Wisconsin Department of Transportation

**Proposal #11: Project ID 5310-02-74
Spring Green - Madison
CTH KP – Westview Ct
Village of Cross Plains
USH 14
Dane County**

**Project ID 5657-00-70, WISC 2014 187
Pine Bluff – V Cross Plains
Black Earth Creek BR, B-13-0646
CTH P
Dane County**

This is Addendum No. 1, which provides for the following:

Addendum No. 1
ID 5310-02-74 &
ID 5657-00-70
Revised Sheet 30
May 2, 2014

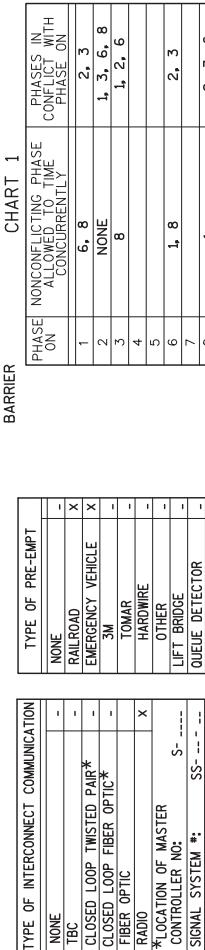
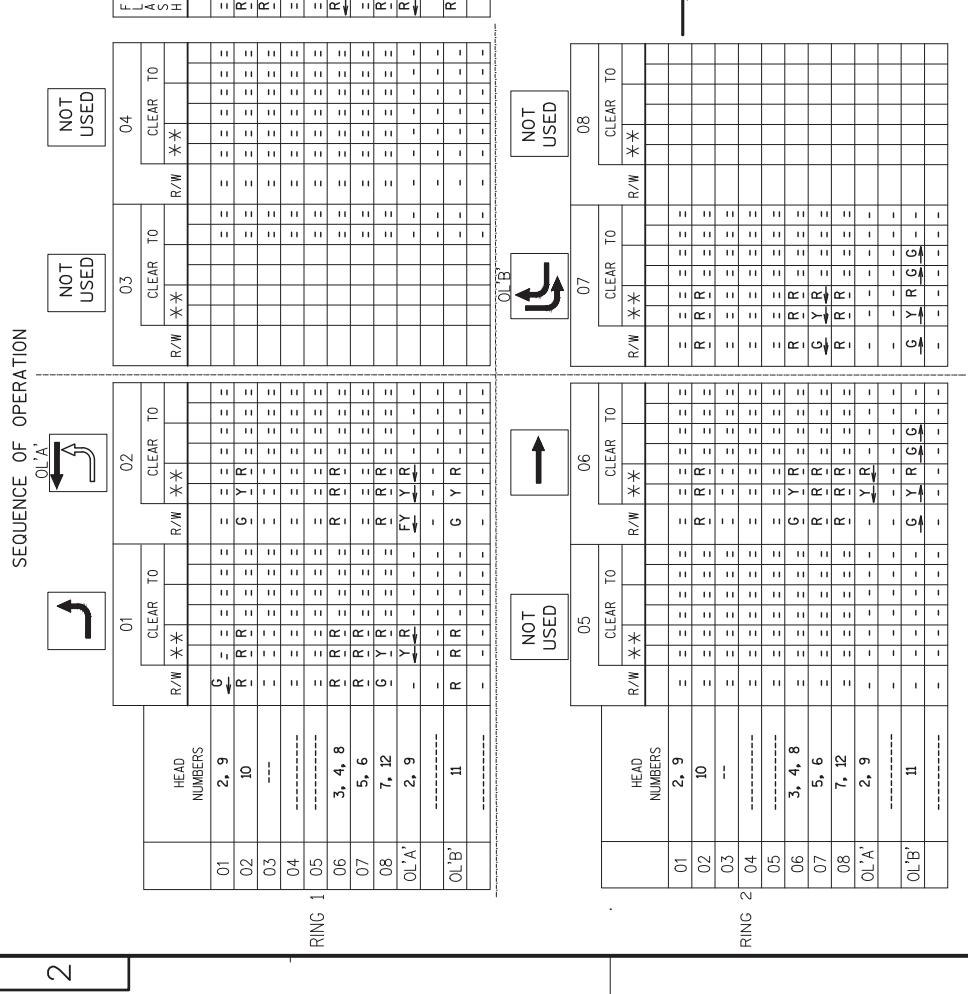
Revised Plan Sheets	
Plan Sheet	Plan Sheet Title (brief description of changes to sheet)
19	Removal Plan: The revision includes the traffic signal removal items.
29	Temporary Signal Plan – CTH KP and Bourbon Road: The revision includes addition/removal/change of signal faces, addition/removal of notes, detection zones, inclusion of pavement markings.
30	Temporary Signal Plan – CTH P and Bourbon Road: The revision includes addition/removal/change of signal faces, addition/removal of notes, detection zones, inclusion of pavement markings.
31	Temporary Signal Plan – CTH P and USH 14: The revision includes addition/removal/change of signal faces, addition/removal of notes, detection zones, inclusion of pavement markings.
32	Permanent Signal Plan – CTH P and USH 14: The revision includes the addition/change of loops, addition of transformer and pedestal bases, addition/removal of notes
62	Miscellaneous Quantities (revised quantities)

Addendum No. 1
ID 5310-02-74 &
ID 5657-00-70
Added Sheet 30A
May 2, 2014

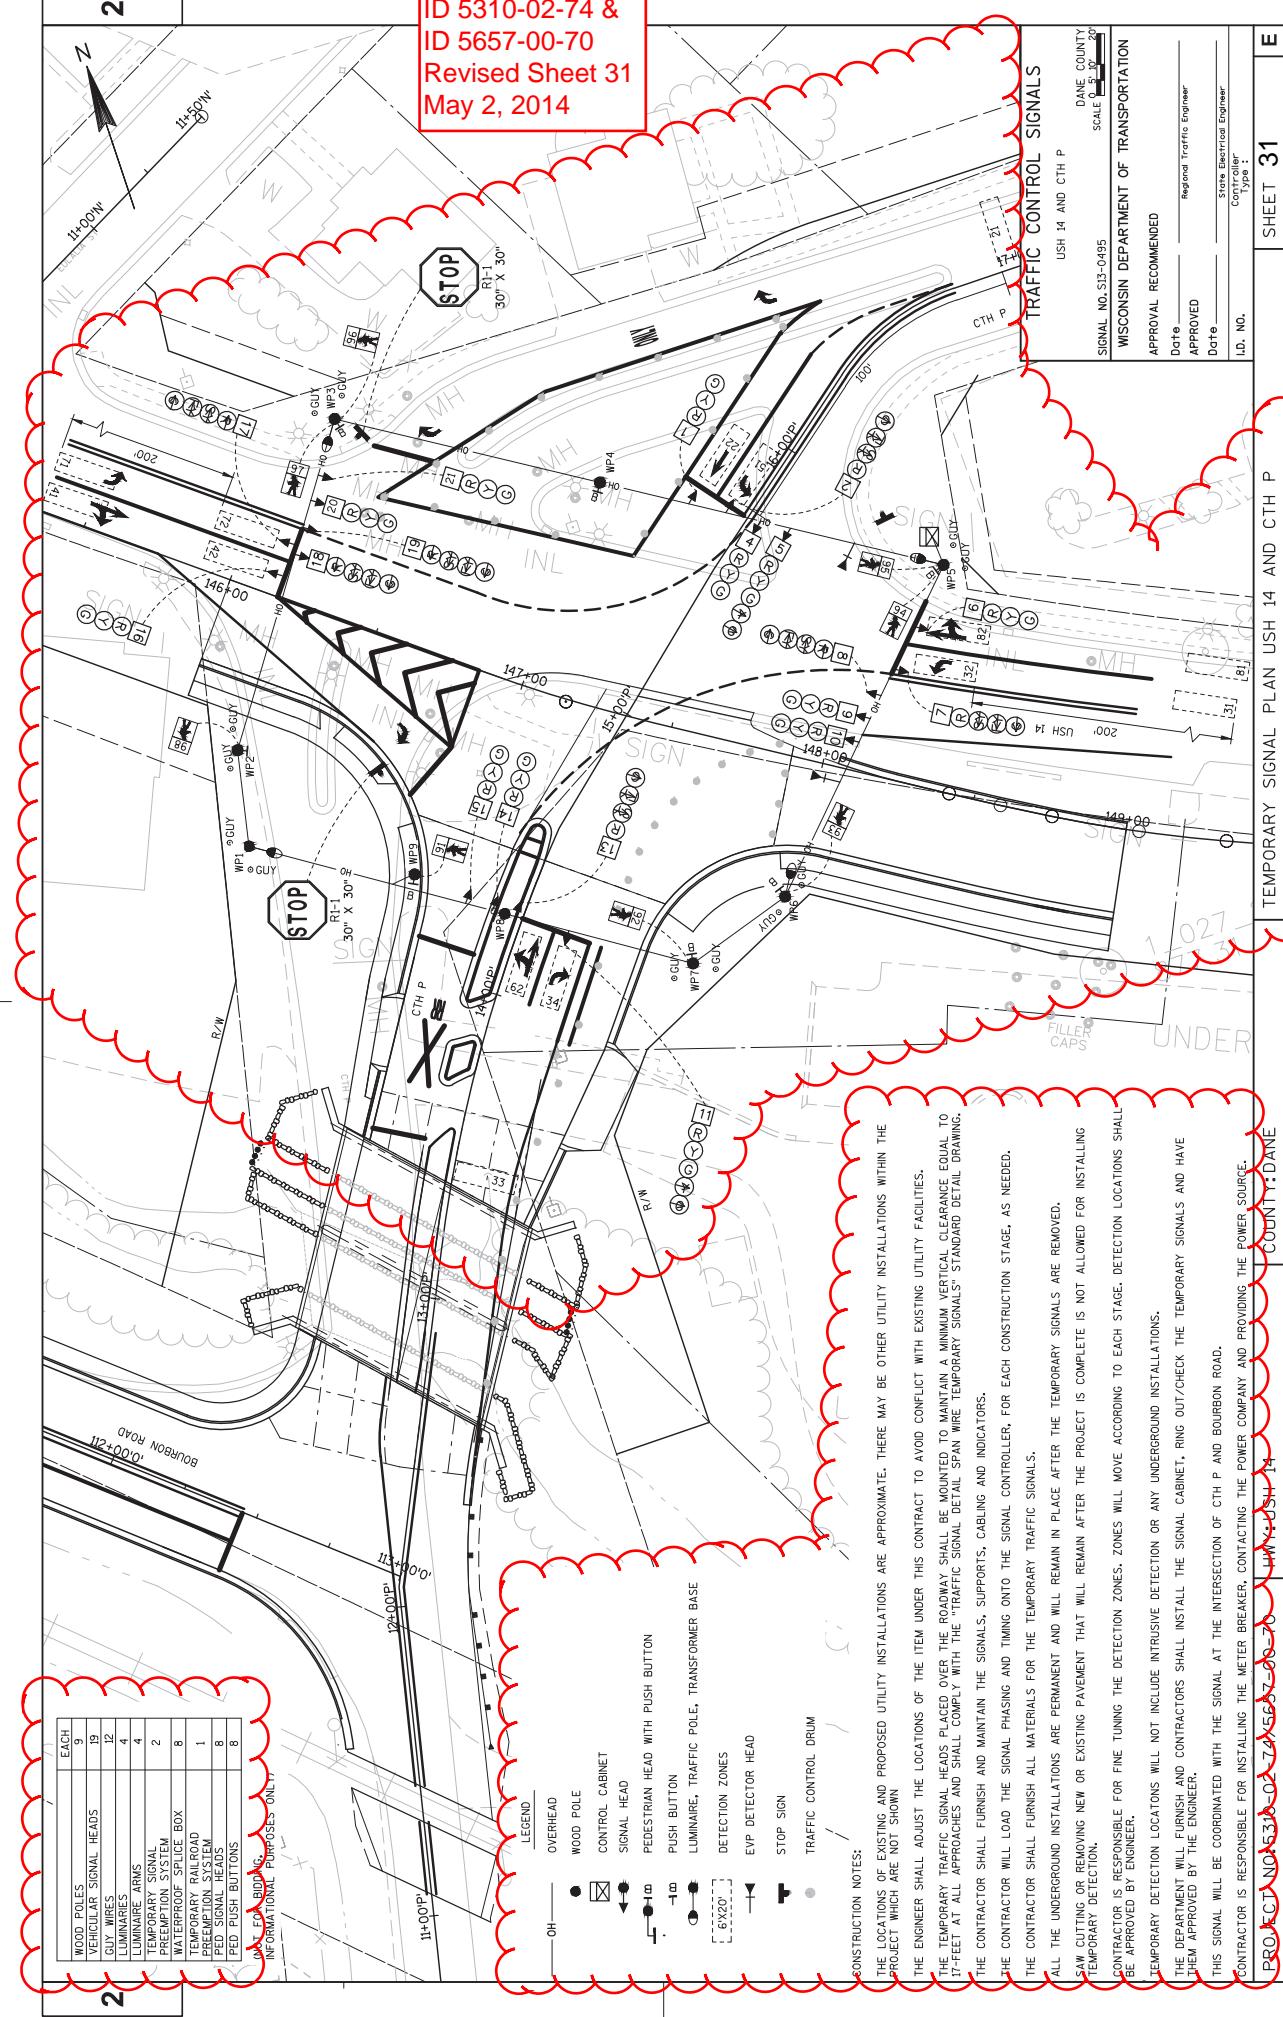
Added Plan Sheets	
Plan Sheet	Plan Sheet Title (brief description of changes to sheet)
29A	Sequence of operations - CTH KP and Bourbon Road
30A	Sequence of operations - CTH P and Bourbon Road
32A	Sequence of operations - CTH P and USH 14
90A	Standard Detail Drawing 09C03-03 Transformer/Pedestal Bases

Addendum No. 1
ID 5310-02-74 &
ID 5657-00-70
Added Sheet 90A
May 2, 2014

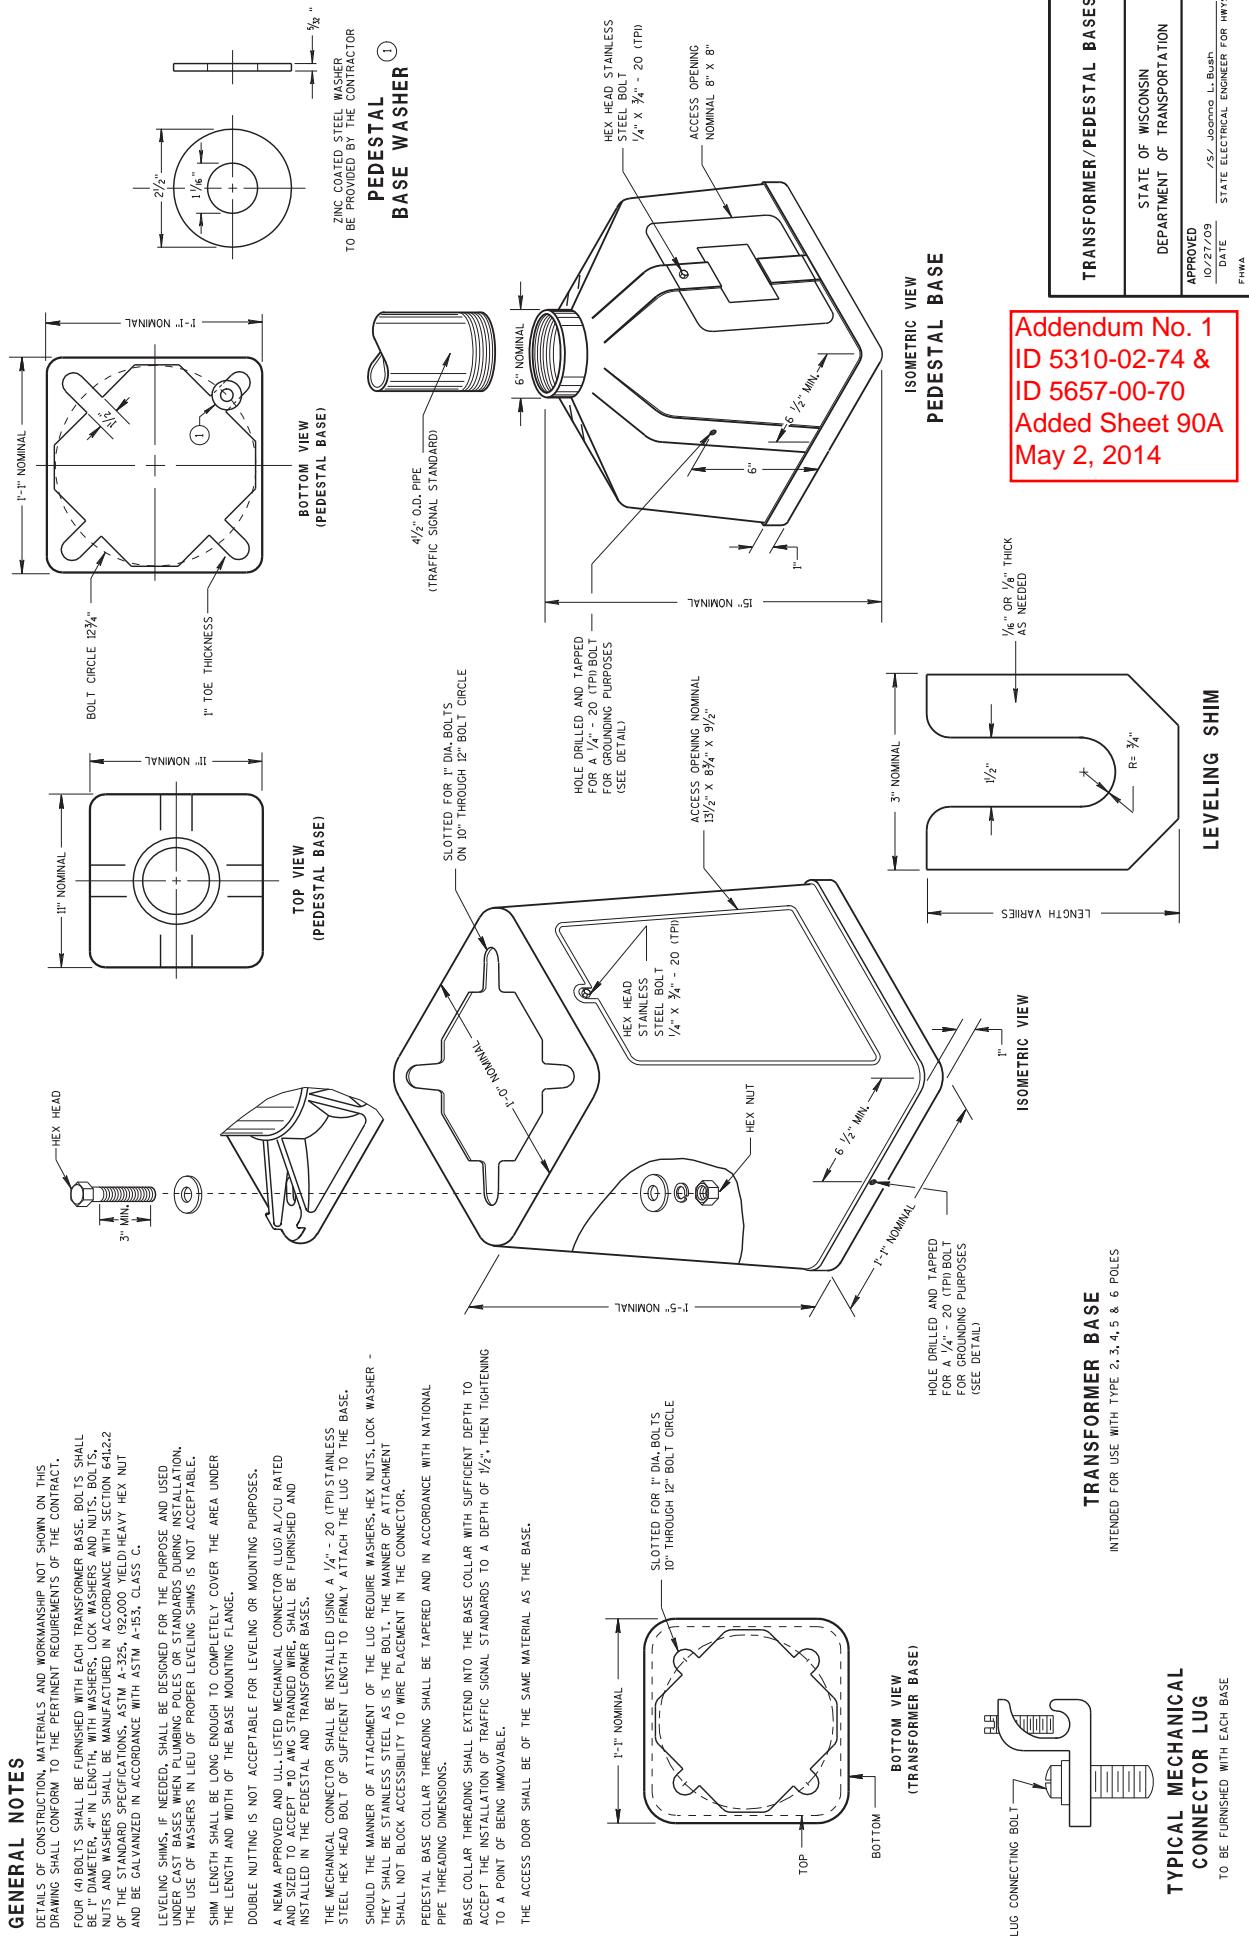
45. Transformers/Pedestal Bases.

In addition to the Standard Specifications section 657.3.5 all transformers/pedestal bases shall be black in color. The transformer/pedestal bases shall be colored black by the manufacturer and shall be delivered to the installing contractor/project already colored black.
